**ENVIRONMENTAL CONSERVATION BOARD AGENDA**

**JUNE 6, 2019 – 7:30 P.M.**

2. Inzano, Anna	188 Bullet Hole Road	63.-1-16.2	Construct Driveway
3. Almodovar & Dinallo	270 West Lake Blvd	64.16-1-28	Construct Pool, Spa, Patio & Retaining Walls

RESIDENTIAL SITE PLAN

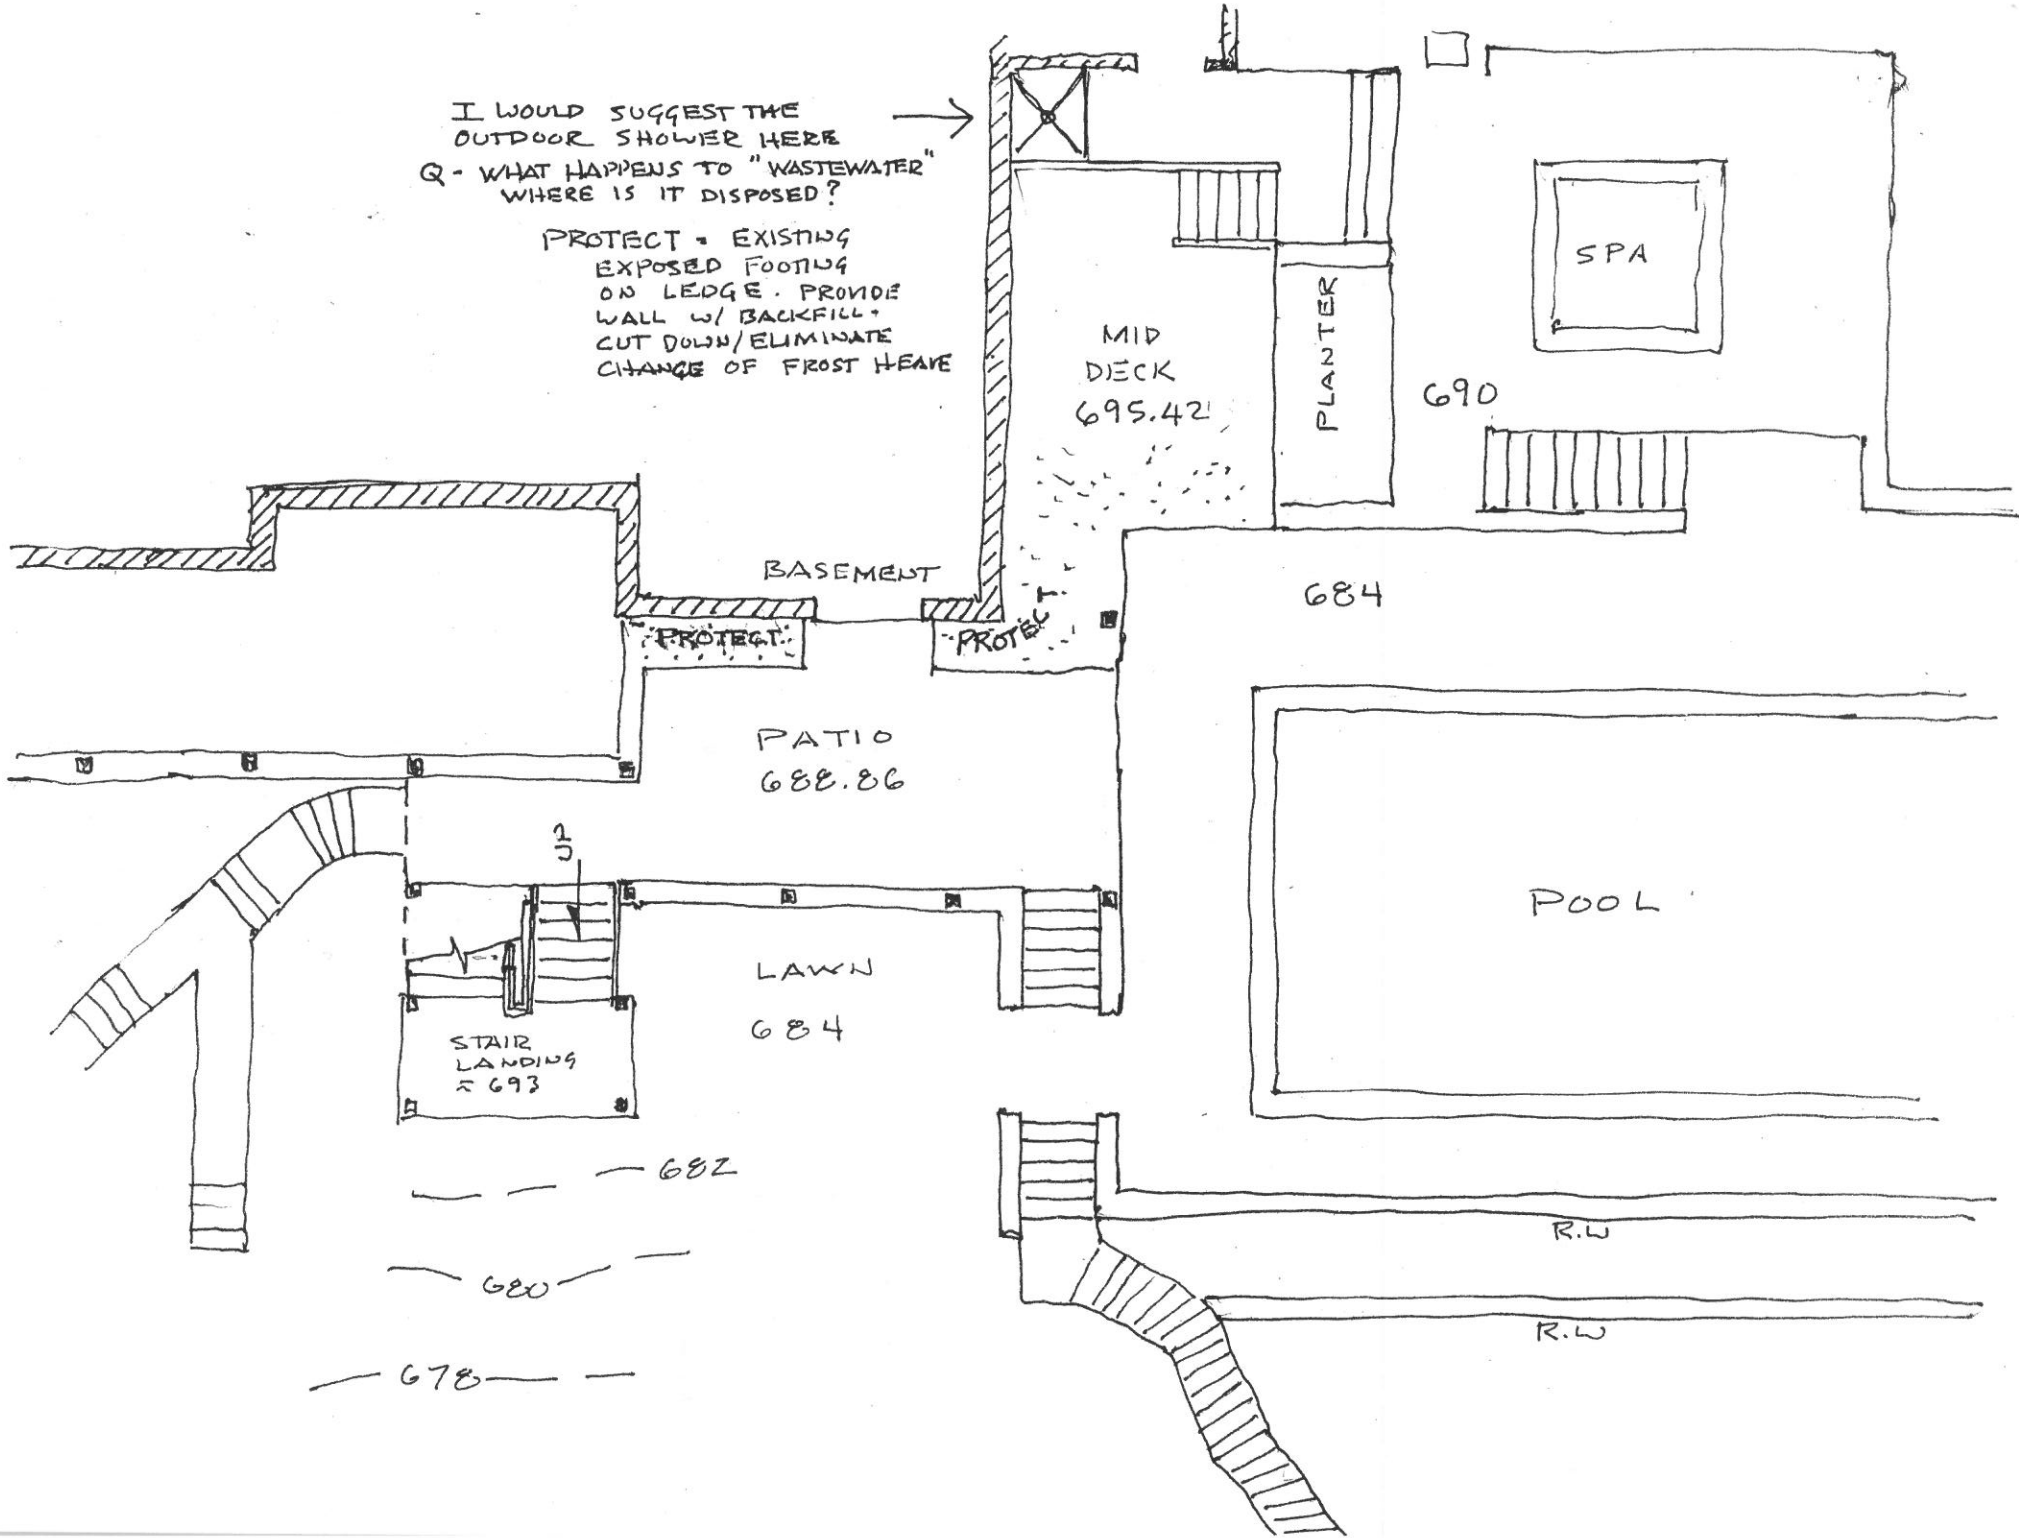
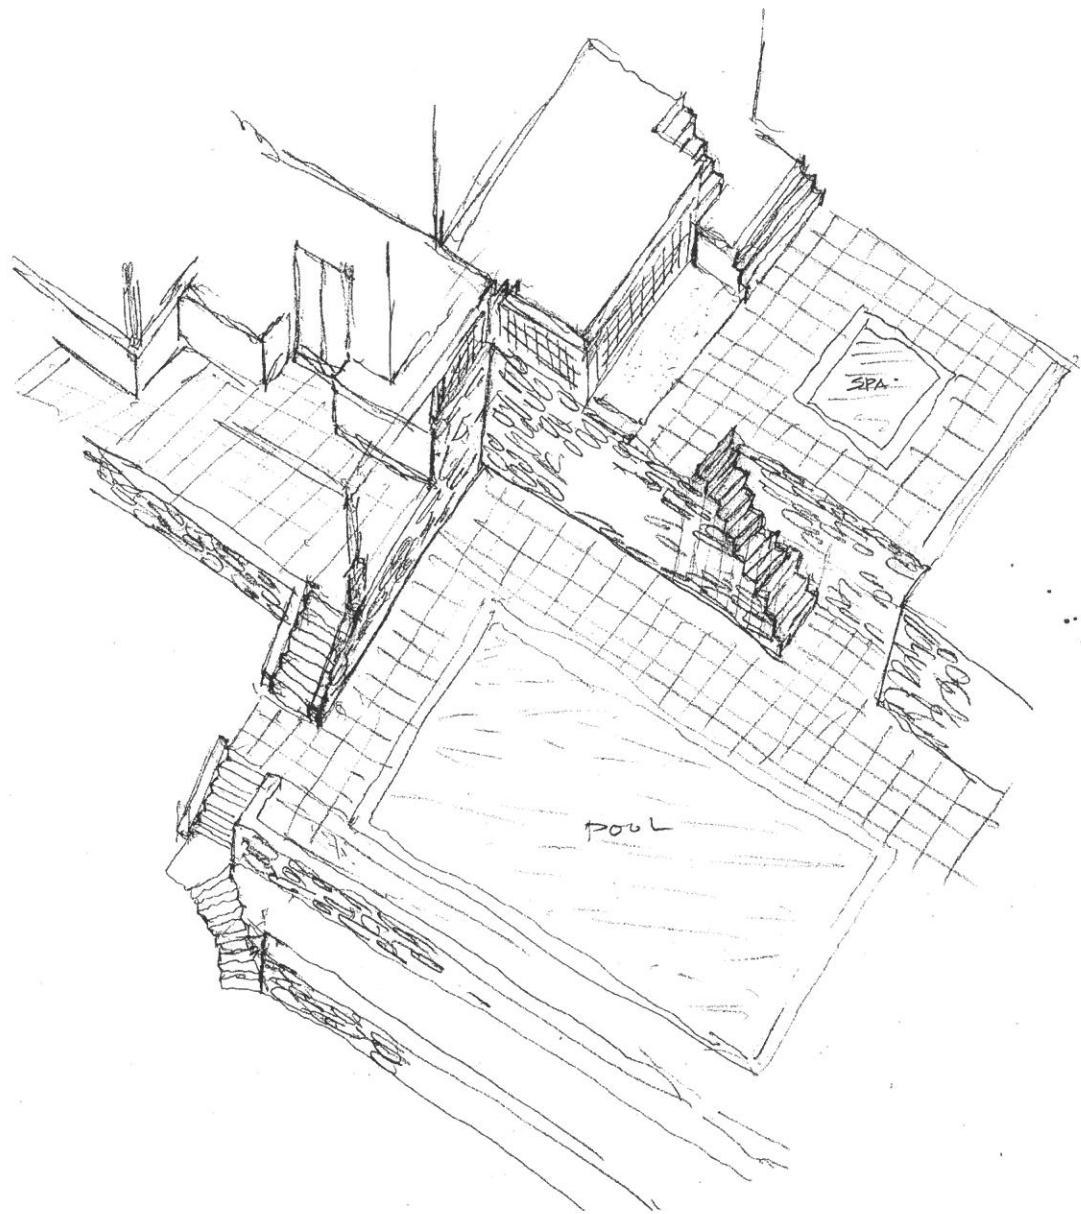
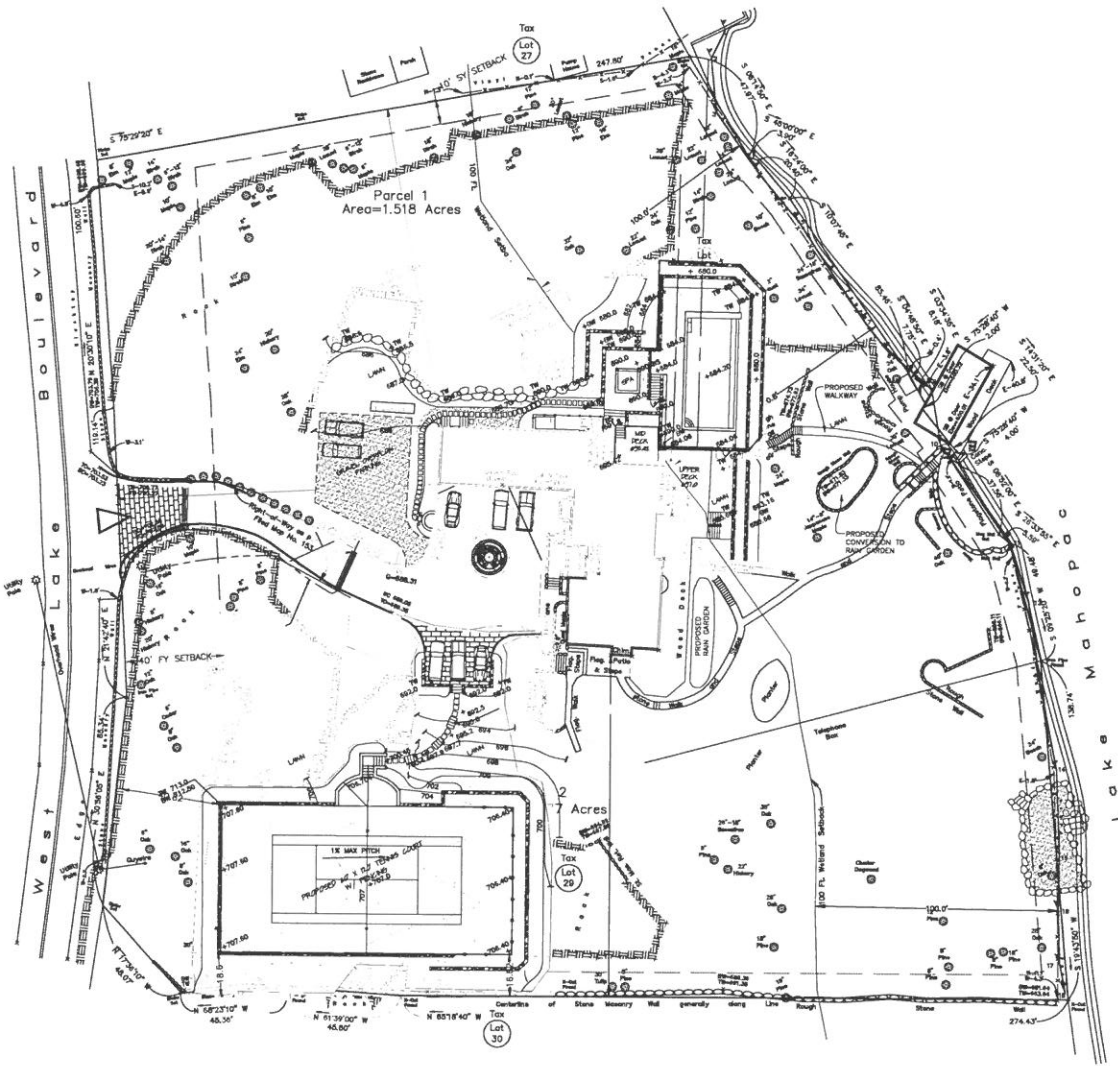
I WOULD SUGGEST THE  
OUTDOOR SHOWER HERE →  
Q - WHAT HAPPENS TO "WASTEWATER"  
WHERE IS IT DISPOSED?

PROTECT - EXISTING  
EXPOSED FOOTING  
ON LEDGE. PROVIDE  
WALL W/ BACKFILL -  
CUT DOWN/ELIMINATE  
CHANGE OF FROST HEAVE
